Office Action Summary

10/720,228

JUNG, DALL-HEE

DETAILED ACTION

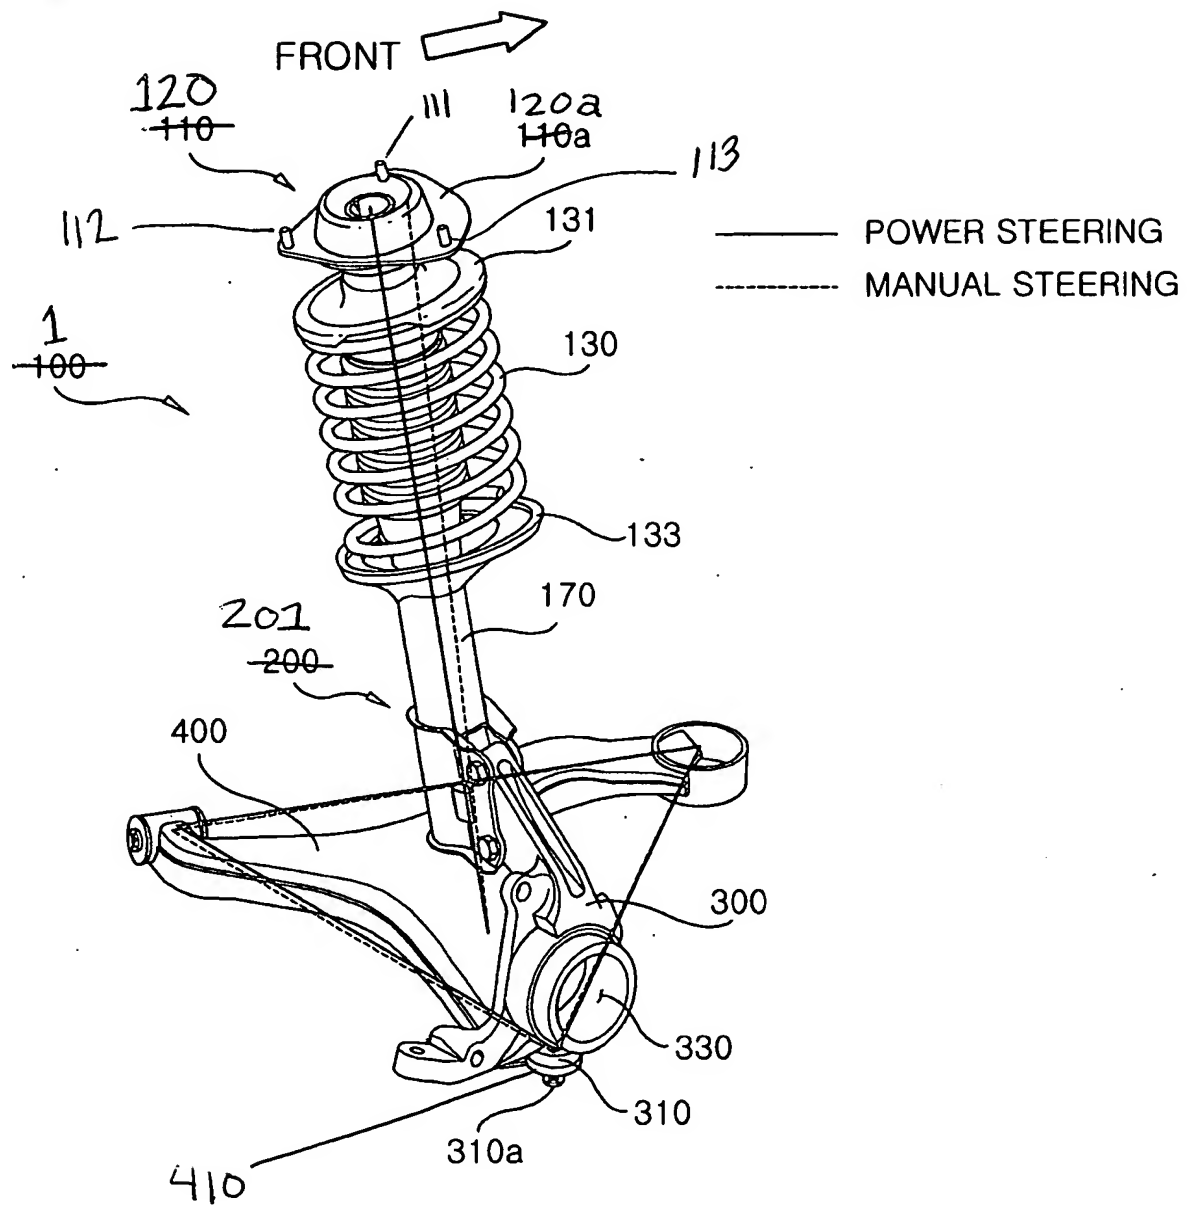
3. The drawings are objected to as failing to comply with 37 CFR 1.84(p)(5) because they do not include the following reference sign(s) mentioned in the description: 410. The detailed description states that reference character "410" is in Figures 2 and 3 (page 7, lines 7-10). Also, reference characters 111, 112, and 113 for mounting bolts are not in Figure 2, in which the detailed description describes their location (page 8, lines 1-2). A copy of marked up drawings with examiner suggestions is included. Corrected drawing sheets in compliance with 37 CFR 1.121(d) are required in reply to the Office action to avoid abandonment of the application. Any amended replacement drawing sheet should include all of the figures appearing on the immediate prior version of the sheet, even if only one figure is being amended. Each drawing sheet submitted after the filing date of an application must be labeled in the top margin as either "Replacement Sheet" or "New Sheet" pursuant to 37 CFR 1.121(d). If the changes are not accepted by the examiner, the applicant will be notified and informed of any required corrective action in the next Office action. The objection to the drawings will not be held in abeyance.
